SUBMITTAL IDENTIFICATION SHEET

WEBSTER UNIVERSITY ISB
PROJECT NAME

057100-008
CONTRACTOR / CM SUBMITTAL NO.

Subject: Stair 1 Submittal

SUPPLEMENTAL ELEVATIONS AND DETAILS STAIR 1
WEBSTER UNIVERSITY ISB
CANNON DESIGN

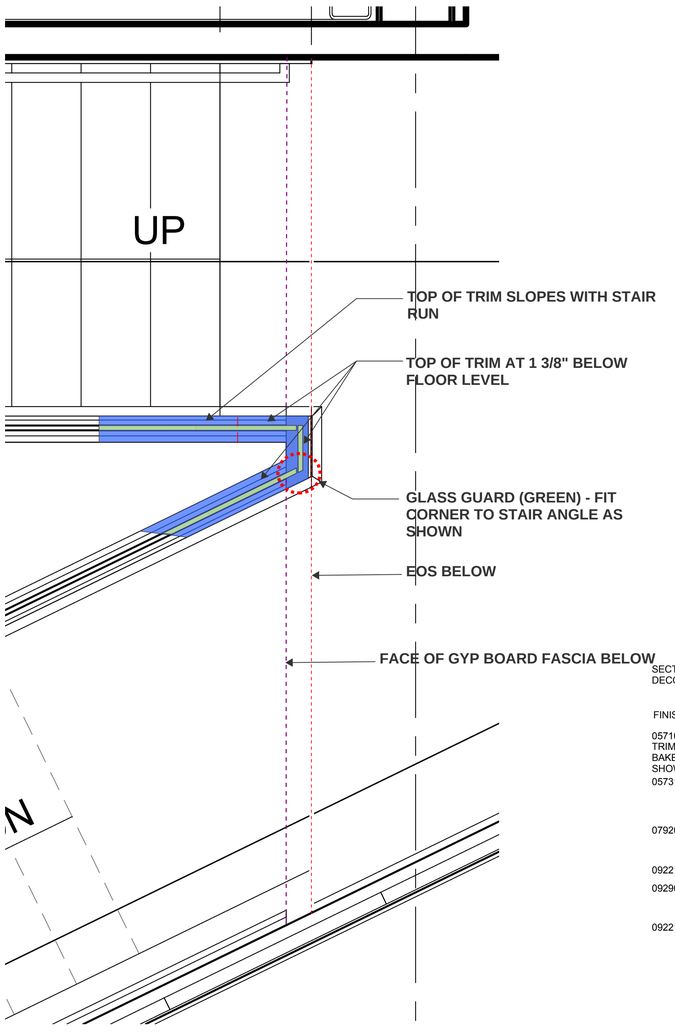
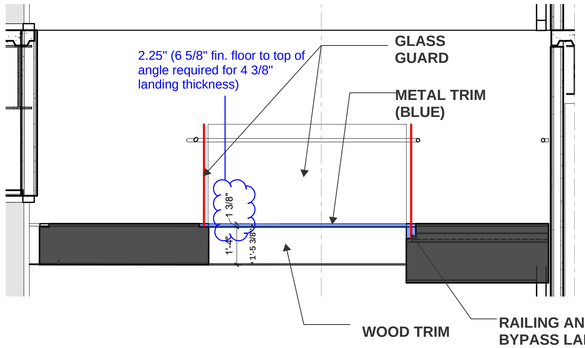
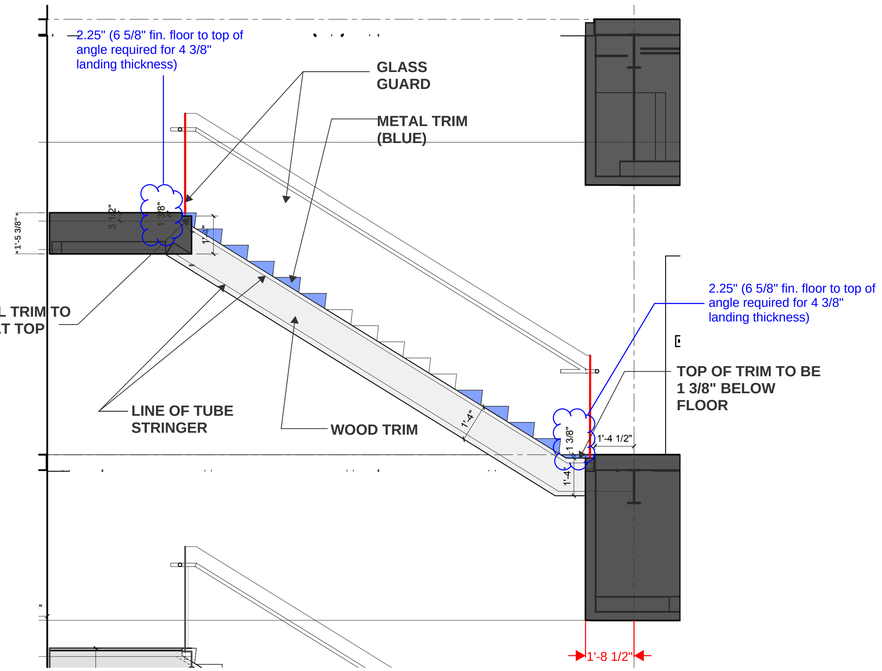
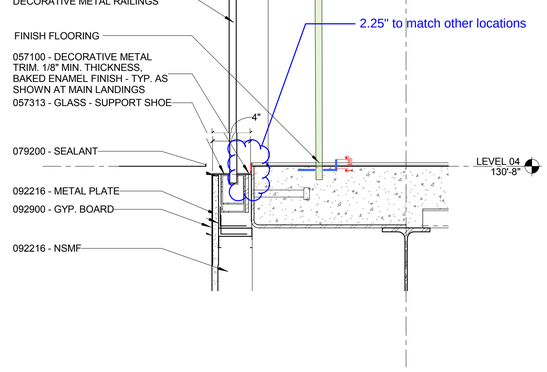
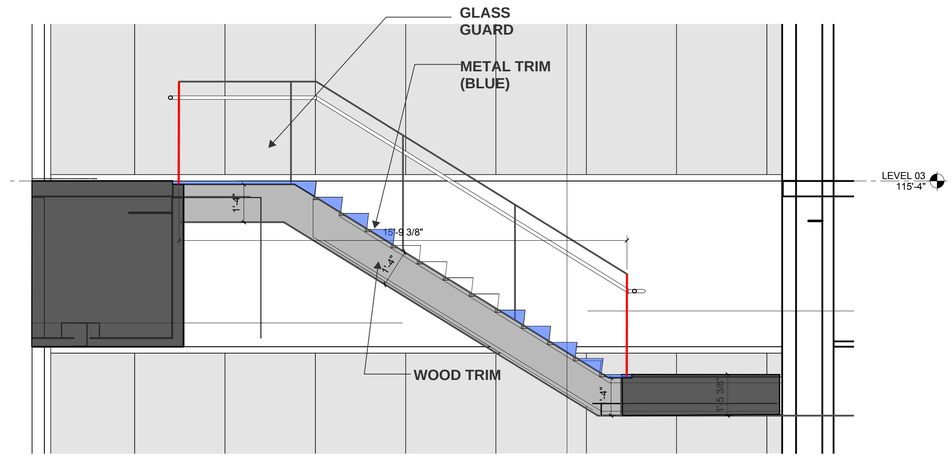
4. Previously sent sketch details included on page 3 for reference with modification shown for landing structure thickness

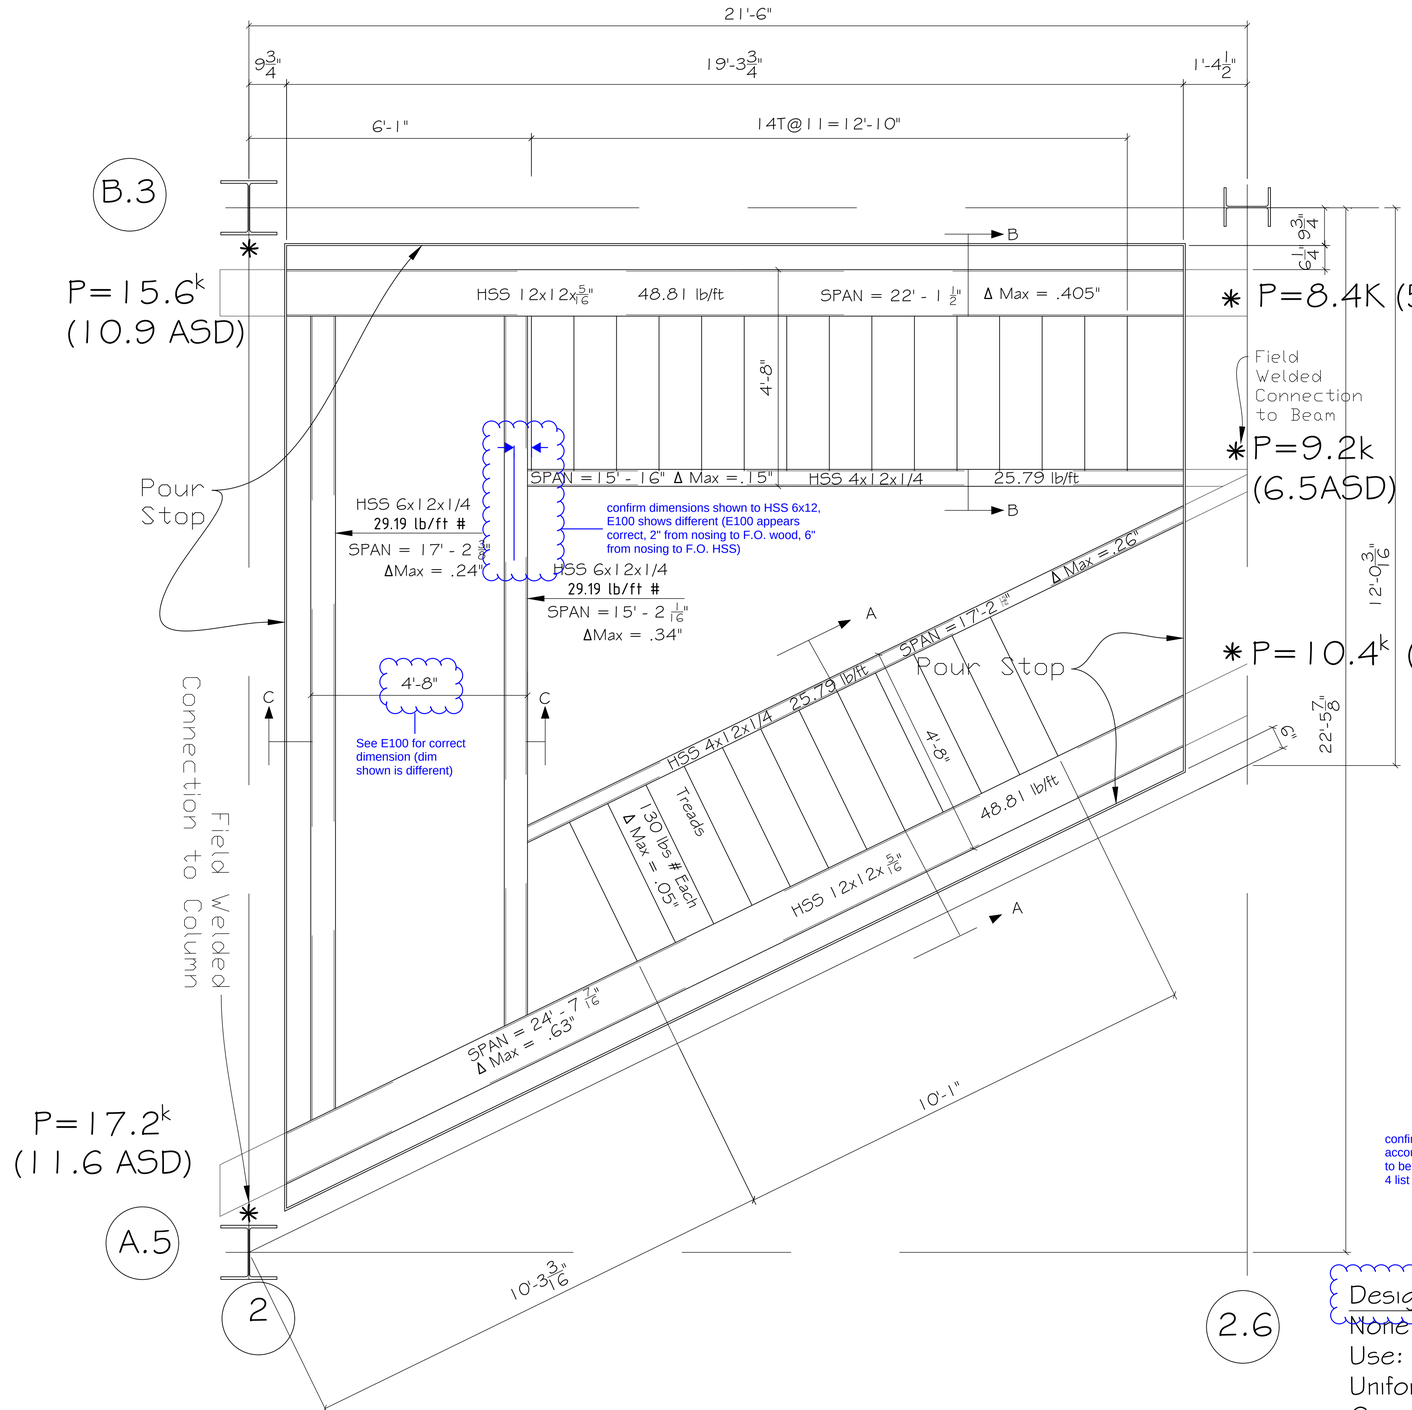
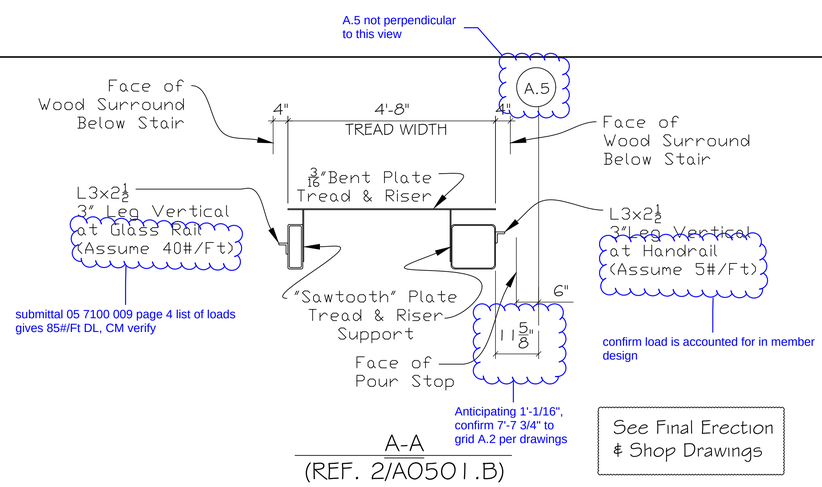
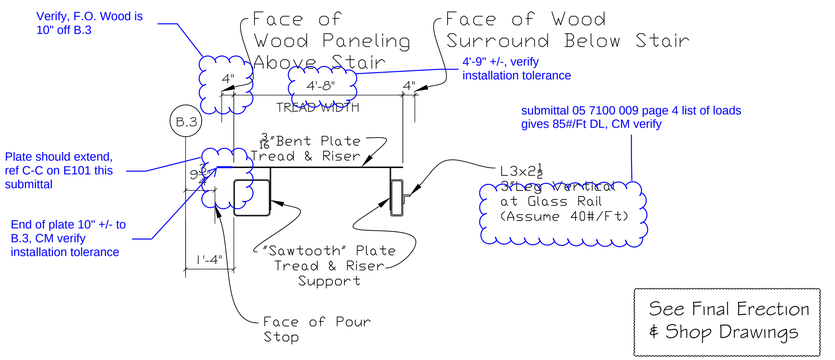
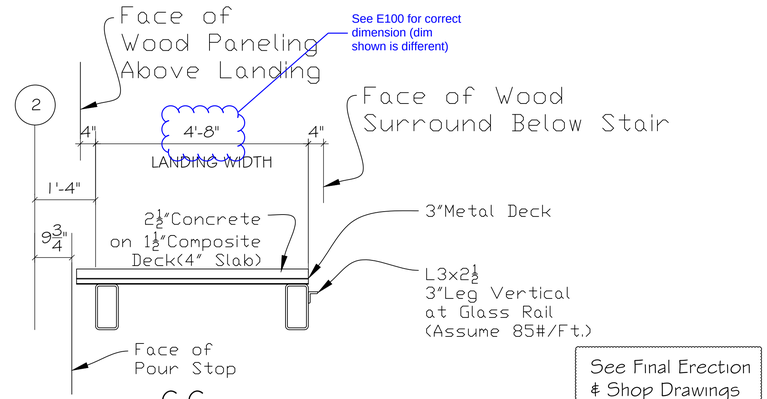
NOTE: Present details for A103 (2), A104 (1), & A102 (2) limit the deflection to l/360. To decrease the center point deflection to 3/8", ADD: $8,305.00.

confirm ALL dead loads are accounted for (cannot confirm wood panel load is included)

NOTE: Rail suppliers, verify the supports meet their code requirements for loading. Our engineering applies only to dead loads!

confirm that 3.5lb/ft wood panel dead load is accounted for in stair design (does not appear to be included in submittal 05 7100 009 page 4 list of loads)

DMA - please verify both items!

these are delegated design items, delegated design engineer is responsible for these items (not DMA)

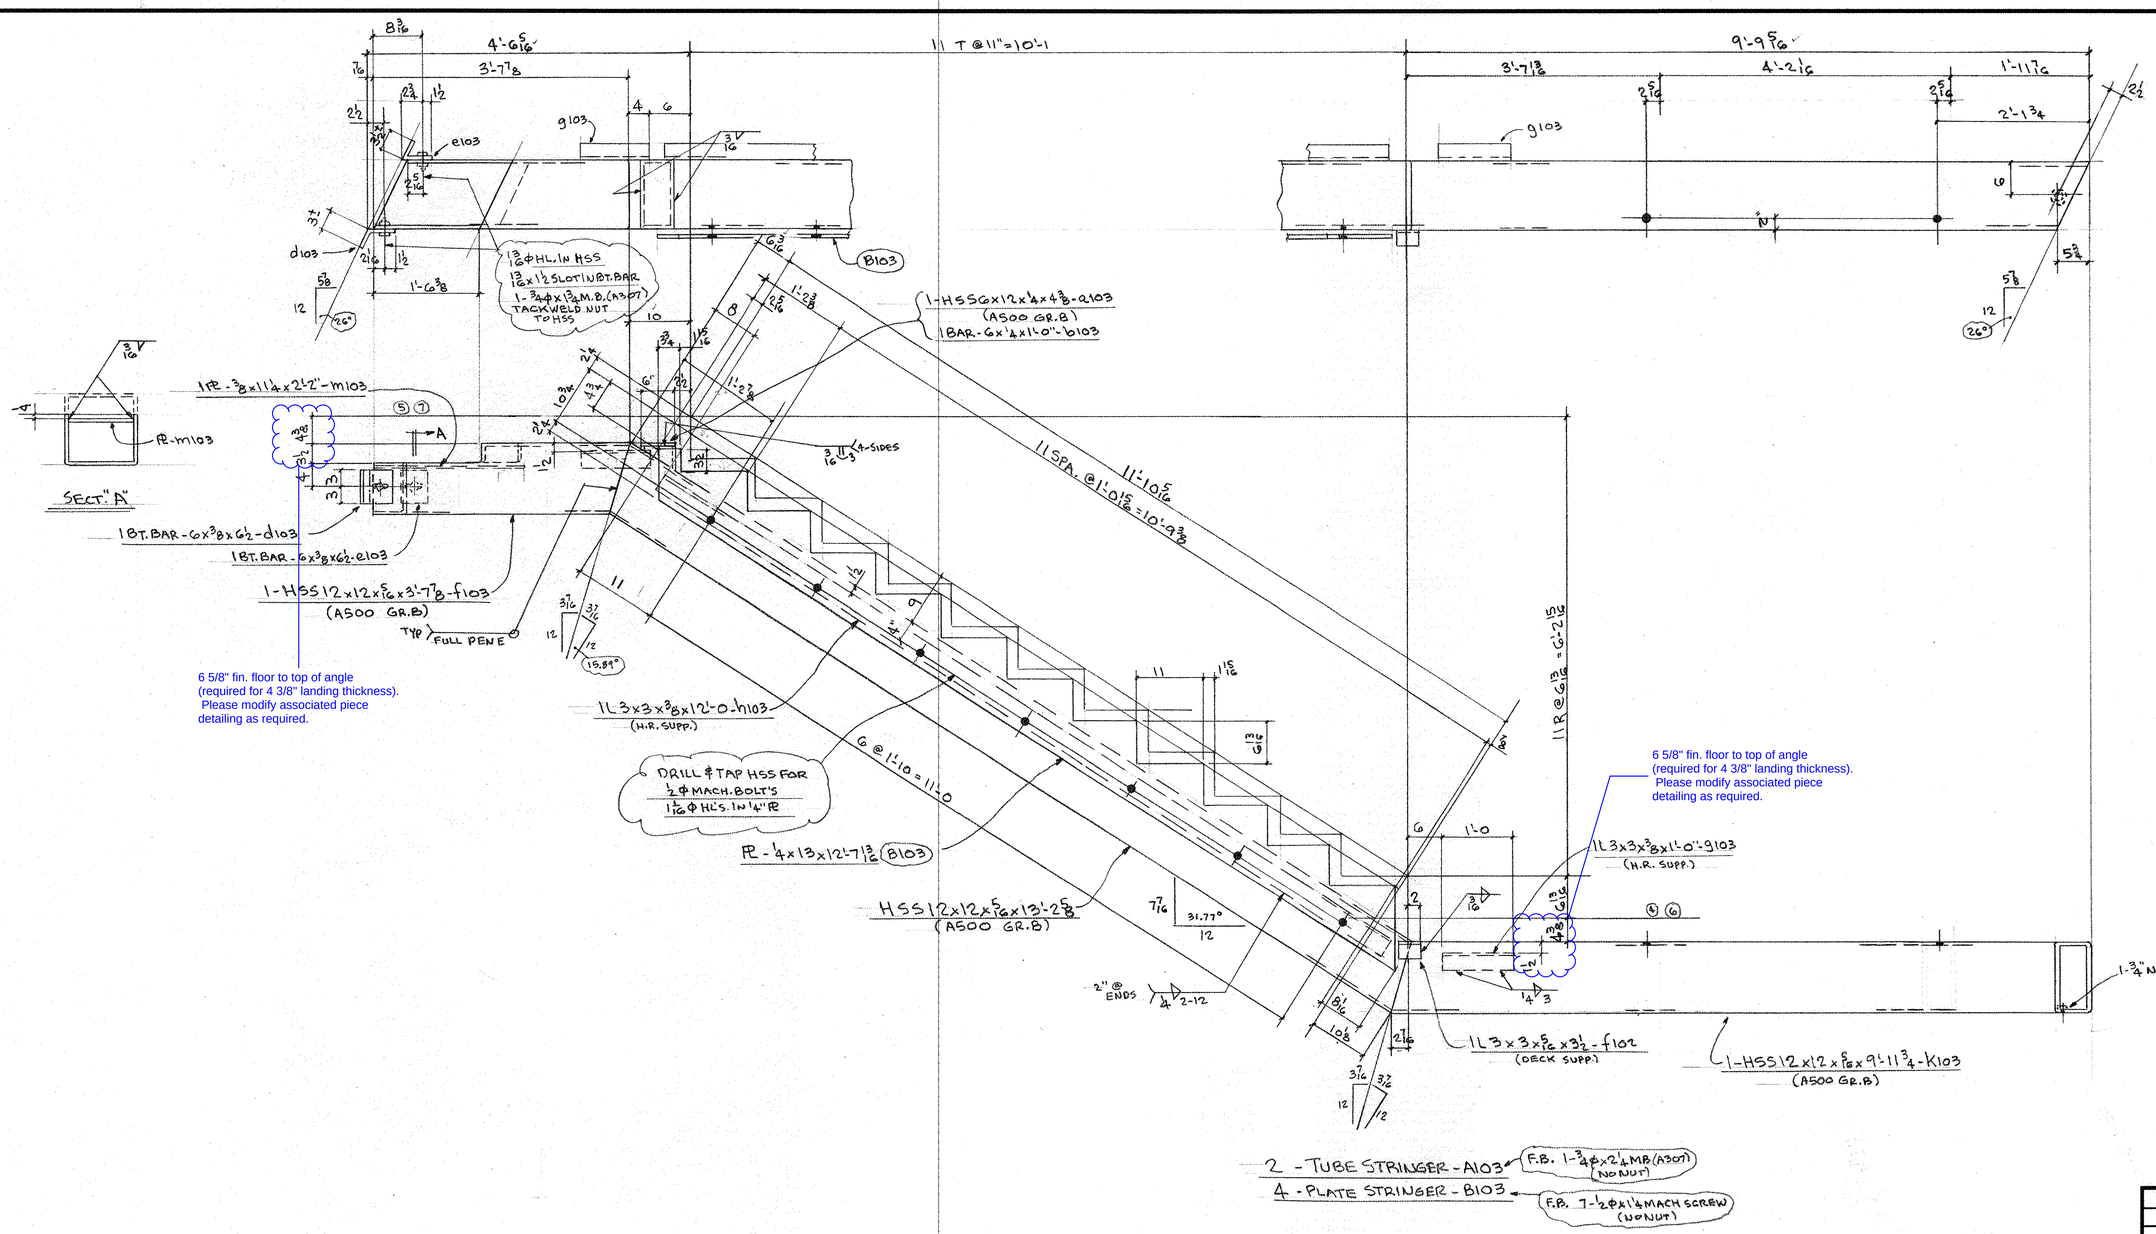
10'-0 5/16"
5 T @ 11" = 4'-7
9'-9 5/16"
9'-1 15/16"
9 15/16"
3'-7 13/16"
4'-2 1/16"
1'-11 7/16"
2'-1 3/4"
1 3/16" Ø HOLE IN HSS
1 3/16" x 1/2" SLOT IN BT. BAR
1-3/4" Ø x 1 3/4" MB (A307) (TACKWELD NUT TO HSS)
6 5/8" fin. floor to top of angle (required for 4 3/8" landing thickness). Please modify associated piece detailing as required.
1-HSS6x12x1/4 x 4'-4 1/2" - e104 (A500 GR.B)
1 BAR - 6" x 1/4" x 1'-0" - b102
1 PL - 3/8" x 11 1/4" x 2'-2" - m103
PL-m103
SECT. "A"
1 BT. BAR - G x 3/8 x G 1/2 - d103
1 BT. BAR - G x 3/8 x G 1/2 - e103
1-HSS12x12x5/16 x 9'-1 15/16" - b104 (A500 GR.B)
1L-g103
4 @ 1'-1 7/16" (c) = 4'-1 1/8"
5'-5 3/16"
5 R @ 7" = 2'-11
1L 3x3x3/8 x 1'-0 - g103 (H.R. SUPPORT)
3/4" NUT (TACKWELD)
HSS12x12x5/16 x 6'-10 1/16" (A500 GR.B)
DRILL & TAP HSS FOR 1/2 Ø MACH SCREWS 1 1/16 Ø HOLES IN 1/4" PL
PL-1/4 x 13 x 6'-2 1/16" (B104)
3 @ 1'-8 = 5'-0

32.47°
1L-3x3x3/8 x 5'-6 - d104
1-HSS12x12x5/16 x 9'-11 1/16" - a104 (A500 GR.B)
1L 3x3x5/16 x 3 1/2 - f102 (DECK SUPPORT)
FULL PENE. TYP
6 5/8" fin. floor to top of angle (required for 4 3/8" landing thickness). Please modify associated piece detailing as required.
ONE - TUBE STRINGER - A104
2 - PLATE STRINGER - B104
F.B. 1-3/4 Ø x 2 1/4 MB (A307) (NO NUT)
F.B. 4-1/2 Ø x 1 1/4 MACH SCREW (NO NUT)
BAR-m104
SECT. "B"
10'-11 3/8"
9 15/16"
5T @ 11" = 4'-7
1'-5 9/16"
1 BAR - 3 x 3/8 x 7 - g101
1-3/4 Ø x 1 1/2 MB (A307) (T.W. NUT TO HSS)
8 @ 1'-0 = 8'-0
15/16" x 2 SLOTS
4 @ 2'-0 = 8'-0
1 BAR - 3 3/8 x 3/8 x 1'-10" - m104
1-HSS6x4x1/4 x 4 1/2 - h104
1-BAR-4 x 1/4 x 6 - k104
6 @ 1'-0 = 6'-0
1 BAR - 4 1/2 x 3/8 x 6 - m104
1 BT. BAR - d103 (W.S.)
1 BT. BAR - e103 (F.S.)
2 - 3/4 Ø x 1 3/4 MB (A307) (T.W. NUT TO HSS)
13/16" x 1 1/2" SLOT
DRILL & TAP HSS FOR 1/2 Ø MACH. SCREWS 1 1/16 Ø HOLES IN 3 x 3/8
L3x3x3/8 x 8'-11 1/2" (E104)

1-HSS12x4x1/4 x 10'-11 3/8" - g104 (A500 GR.B)
5 R @ 7" = 2'-11
3'-6
6 5/8" fin. floor to top of angle (required for 4 3/8" landing thickness). Please modify associated piece detailing as required.
ONE - TUBE STRINGER - D104
ONE - ANGLE - E104
ONE - Do - F104
3 - Do - G104
F.B. 1-3/4 Ø x 1/2 MB (A307) NONUT
F.B. 1/2 Ø x 1 1/4 MACH SCREW (NO NUT)
5 - FOR E104
4 - FOR F104
2 - FOR G104
L3x3x3/8 x 6'-4" (F104)
DRILL & TAP NEAR WALL & FAR WALL OF HSS FOR 1/2 Ø MACH. SCREWS 1 1/16 Ø HOLES IN 3 x 3/8
HSS12x4x1/4 x 6'-10 1/16" (A500 GR.B)
DRILL & TAP HSS FOR 1/2 Ø MACH. SCREW'S 1 1/16 Ø HOLES IN 3 x 3/8
L3x3x3/8 x 1'-2" (G104)
1-HSS12x4x1/4 x 1'-7 1/8" - f104
8 1/2"
7"

STRUCTURE WEBSTER UNIVERSITY
LOCATION WEBSTER GROVES, Mo. 63119
DESCRIPTION STAIR No. 1 SECTIONS
CUSTOMER ATLAS IRON

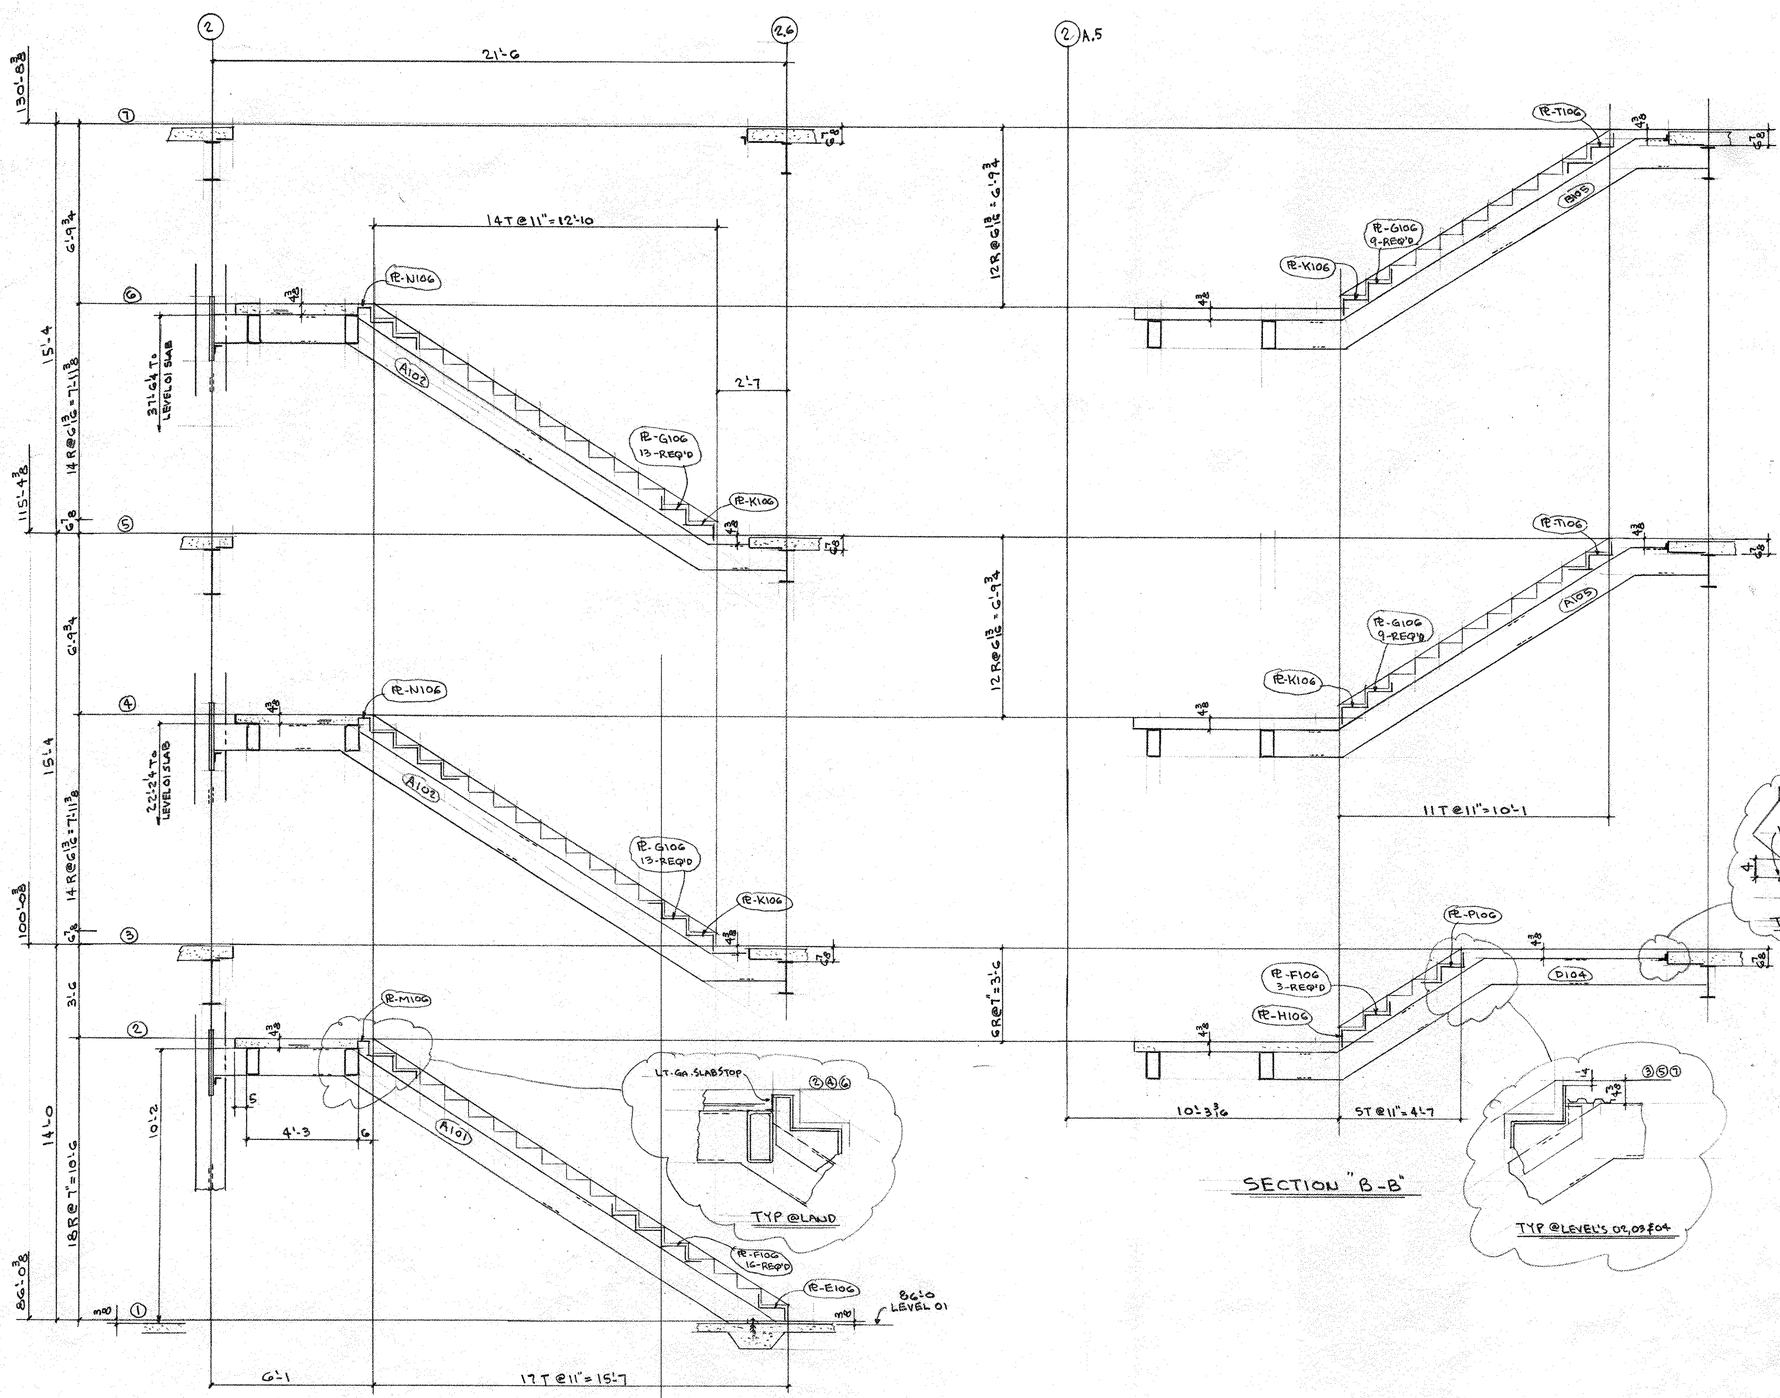
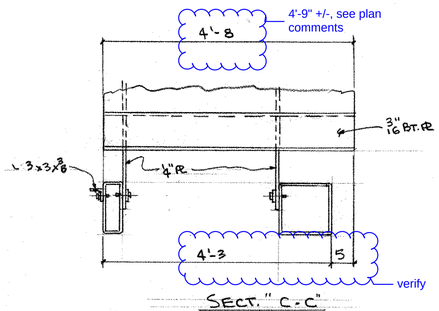
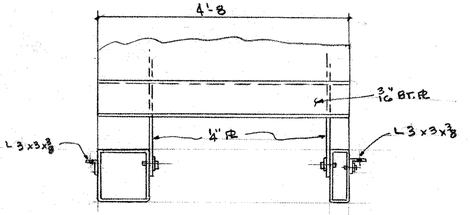
6" to F.O. GWB, plate should extend to this point less tolerance (CM verify)

At intermediate landings there is to be 3/8" poured in place terrazzo on top of 4" slab (2 1/2" normal weight concrete on 1 1/2" composite deck) = 4 3/8" total thickness

6 5/8" fin. floor to top of angle (required for 4 3/8" landing thickness). Please modify associated piece detailing as required.
